Bulletin No. 2003-10r1

Hairpin Cotter 18-859746 is NLA

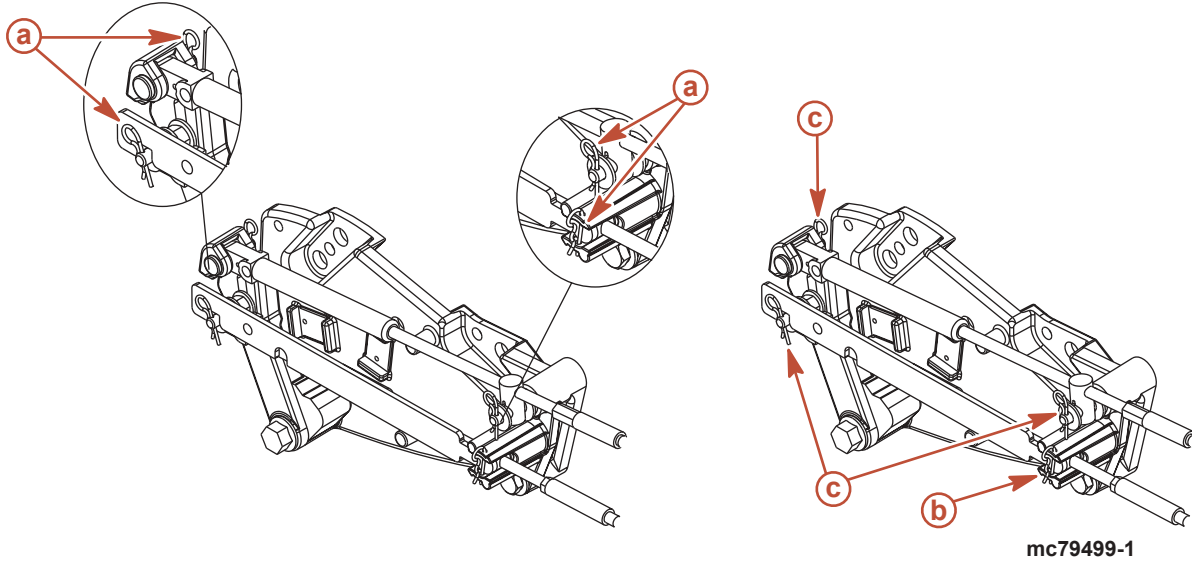
Hairpin cotter 18-859746 that retains the shift cables on the shift plate assembly on all MCM engines must be replaced with (1) of 18-32857-1 cotter pin at the shift cable anchor on the Alpha switch actuating arm and Bravo shift cable retainer plus (3) of 18-21071-1 cotter pins for the two studs and the clevis pin on the shift lever of both the Alpha and Bravo shift plate assemblies.

Qty. 1 of 18-32857-1 cotter pin for transom shift cable retention.  mc79777

Qty. 3 of 18-21071-1 cotter pins for shift lever clevis pin and studs.  mc79778
